PLANNING AND DEVELOPMENT SERVICES STAFF REPORT

For Planning Commission Meeting of September 10, 2013

**SUBJECT: U-Haul Moving & Storage of Ann Arbor Site Plan for City Council Approval
(3655 South State Street)
File No. SP13-007**

**SUBJECT: U-Haul Site Plan for City Council Approval
(3655 South State Street)
File No. SP13-007**

SHEET CONTENTS:
Landscape Plan

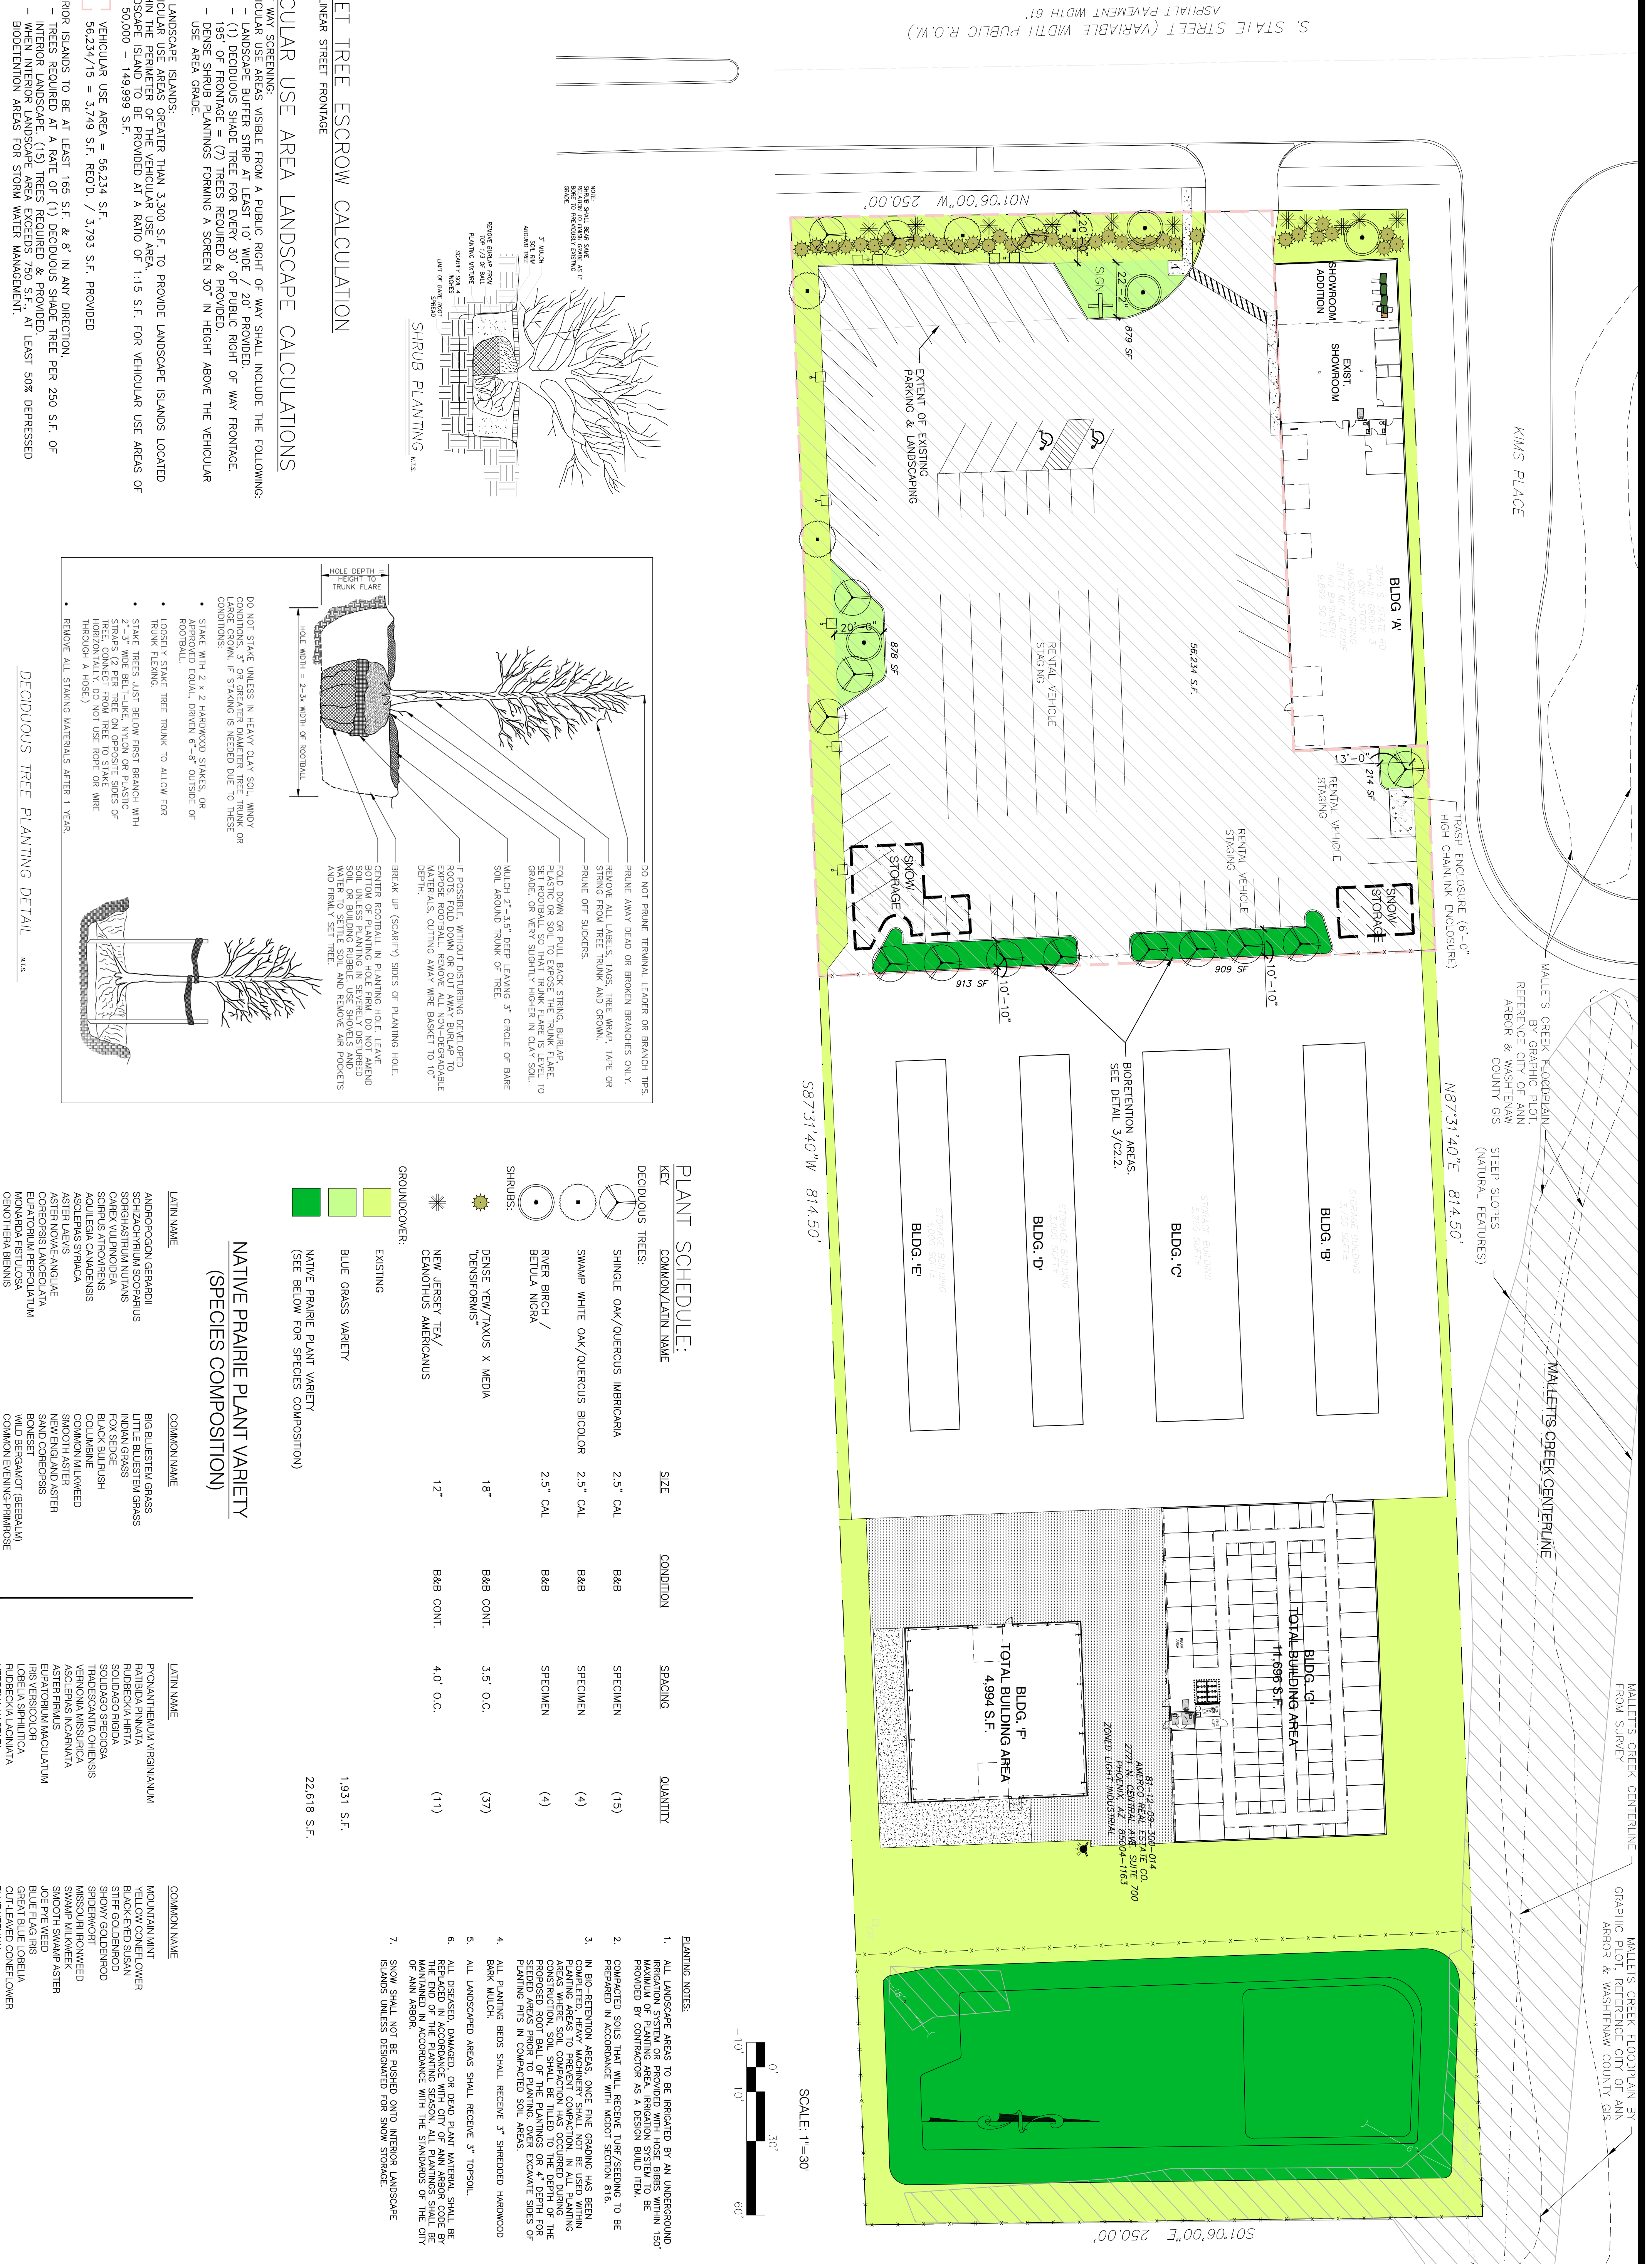
Landscaping along South State – The petitioner has revised the plan to comply with regulations for Right-of-Way landscape buffers. The landscape buffer provided will contain seven trees and dense shrub plantings forming a continuous landscape screen. The Natural Resources Planning Coordinator has completed the review of the revised landscape plan and has confirmed compliance with City Code. A computer image of the proposed view from South State is attached.

Systems Planning (Landscaping) - The proposed plan will bring the site into compliance with current landscaping standards. At this time, the site plan provided does not meet the standards for right-of-way buffer requirements. The petitioner is working to provide the required berm or continuous landscape screen along the front of the property.

1 CONCEPTUAL ARCHITECTURAL FLOOR PLAN / BLDG. 'G' - EGRESS PLAN

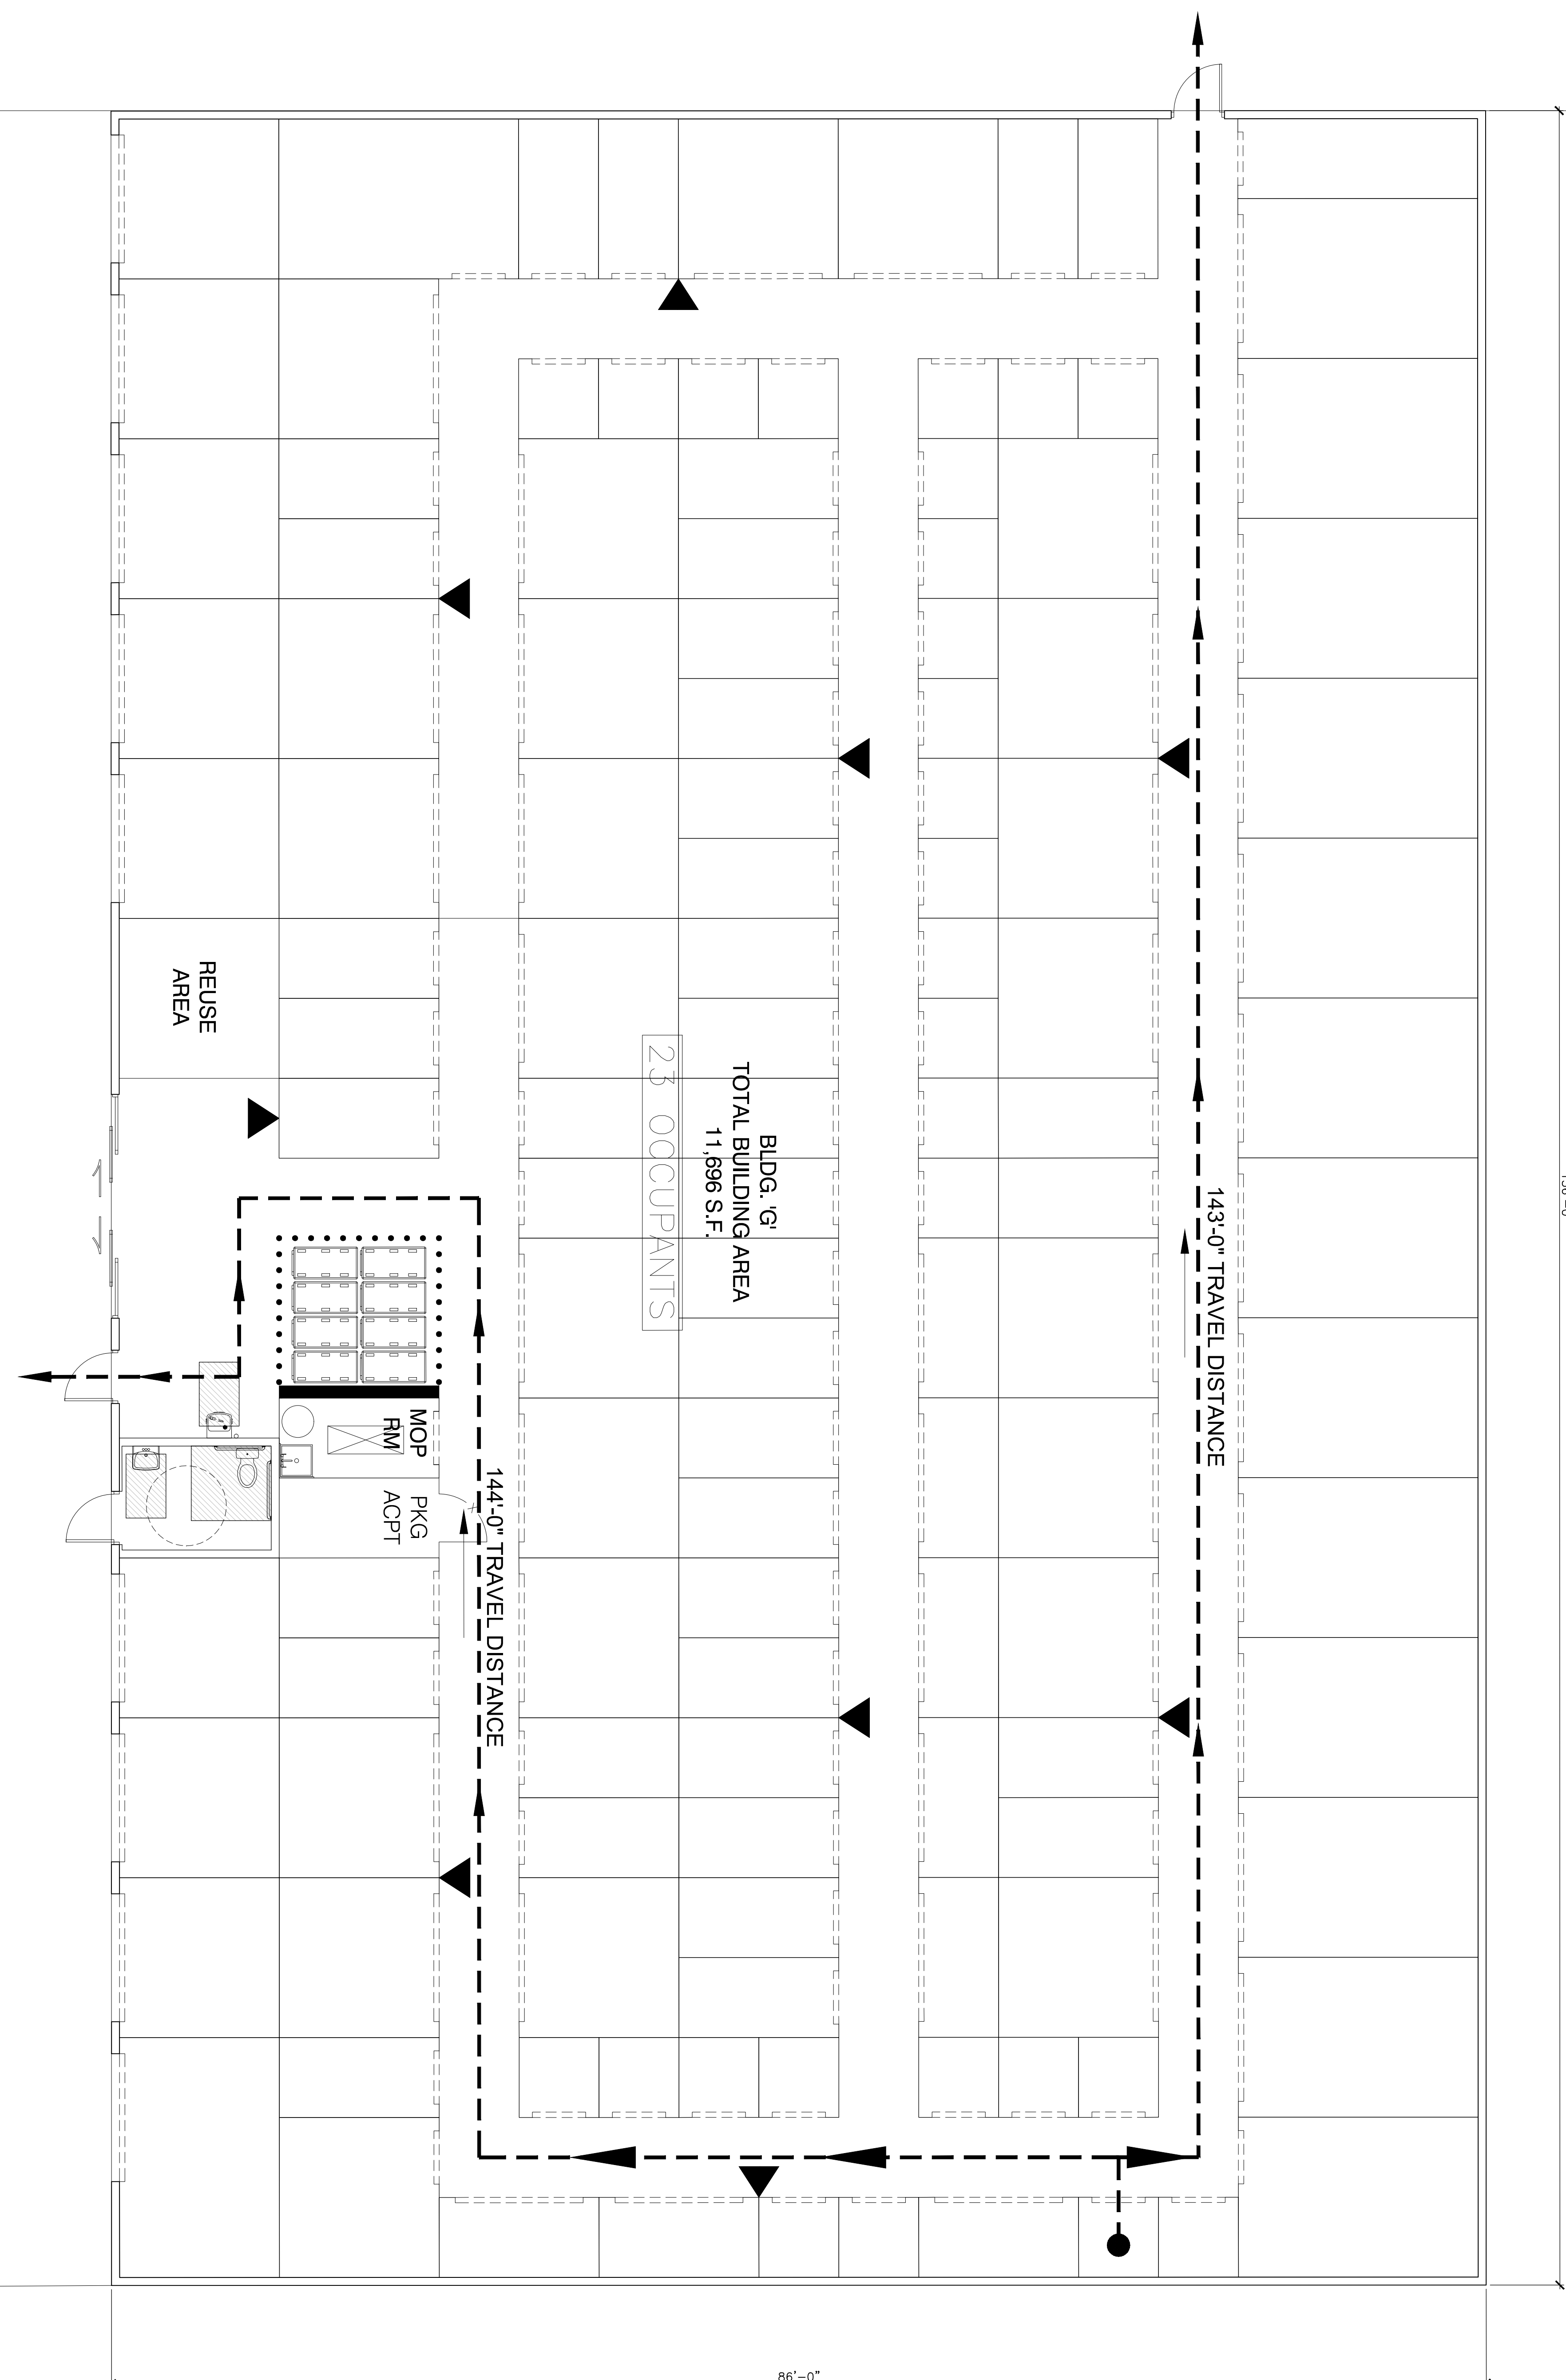
Lighting (Interior and Exterior) – An exterior photometric plan has been attached. At the request of Planning Commission, the petitioner has provided an interior lighting and egress plan for the enclosed self-storage. Interior lighting and egress plans will be reviewed at the building permit stage for adherence to applicable building codes.
